Subject: Dresden Station Unit 3
Additional Information Regarding
Cycle 10 Reload
NRC Docket No. 50-249

RESPONSE TO NRC QUESTIONS ON D3C10 RELOAD

DRESDEN UNIT 3 CYCLE 10 MCPR SAFETY LIMIT ANALYSIS

Figure 3.5-1A

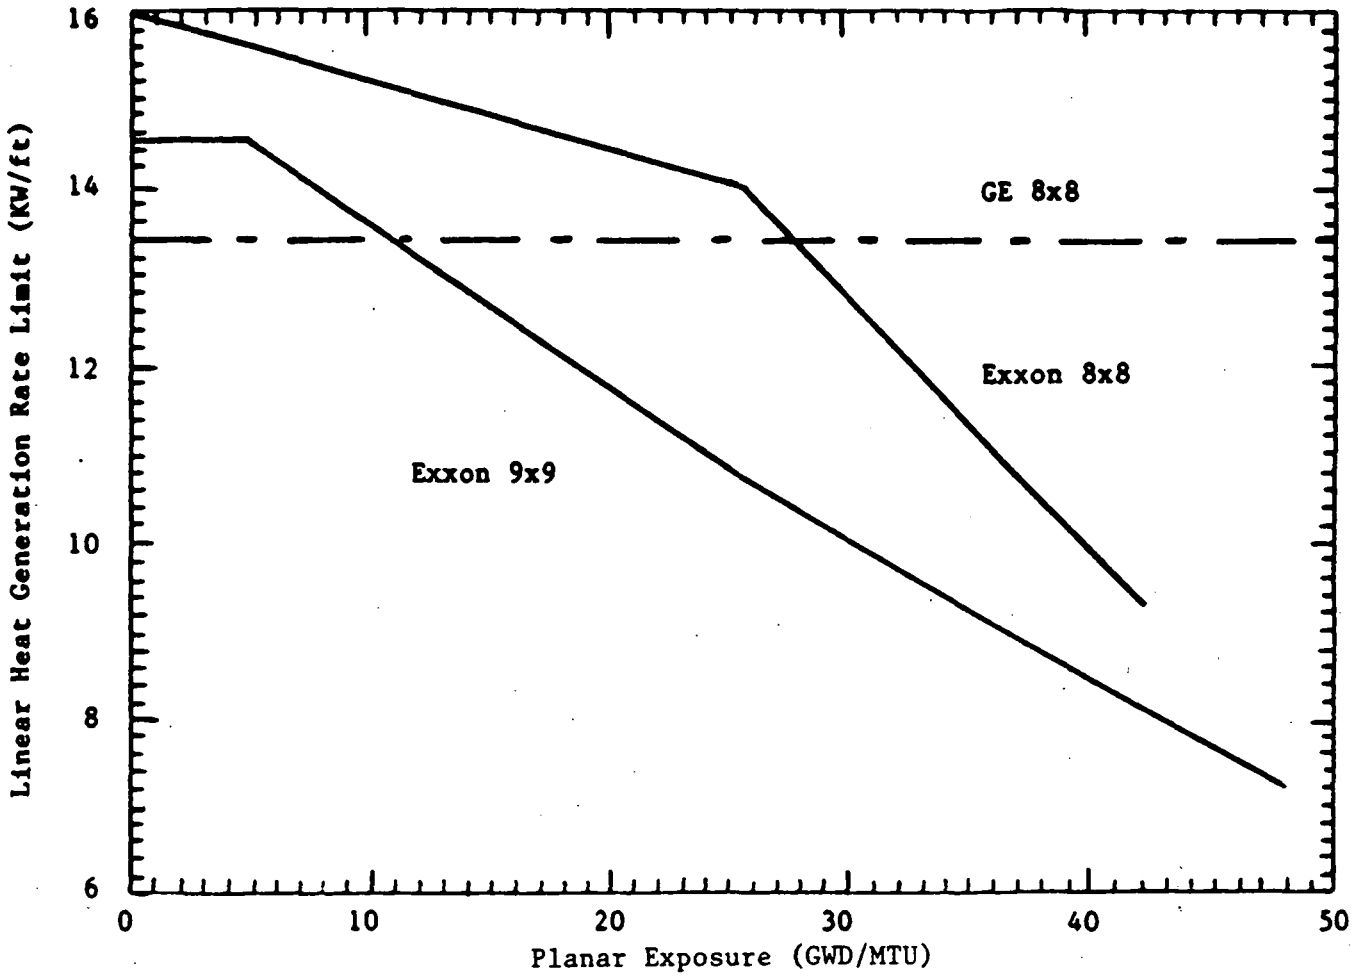
The NRC has previously requested that Dresden incorporate Linear Heat Generation Rate (LHGR) limits into its Technical Specification. CECO submitted proposed limits in Reference (b). When the NRC reviewed the LHGR submittal, several questions arose concerning which of several Exxon documents on fuel mechanical design were the proper source of the data.

The most recent ENC generic mechanical design document which is currently undergoing NRC review is XN-NF-85-67, Revision 1. NRC approval of this topical report is expected within the next few weeks (before the D3C10 startup). During recent conference calls between CECO, Exxon and the NRC, it was agreed that CECO would submit LHGR limit curves for both ENC 8x8 and ENC 9x9 fuel based on Figures 3.1 and 3.2, respectively of XN-NF-85-67, Revision 1 for D3C10. These curves express fuel burnup in terms of planar exposure as monitored by the site software (POWERPLEX). The attached Technical Specification Figure 3.5-1A reflects the curves, also in terms of planar average exposure.

Attachment 1 responds to questions 1, 2 and 3 of the reference (a) letter and includes a revised Technical Specification Figure 3.5-1A indicating linear heat generation rate limits. This figure supercedes the one transmitted with reference (b) and should be incorporated in our proposed Cycle 10 Technical Specifications. This attachment also includes a clarification of the proposed MCPR operating limits for Cycle 10 in response to questions raised during telecons with your staff.

<u>Exxon 8x8 Fuel</u>	
Exposure	LHGR
0.00	16.00
25.40	14.10
42.00	9.30

<u>Exxon 9x9 Fuel</u>	
Exposure	LHGR
0.00	14.50
5.00	14.50
25.20	10.80
48.00	7.20
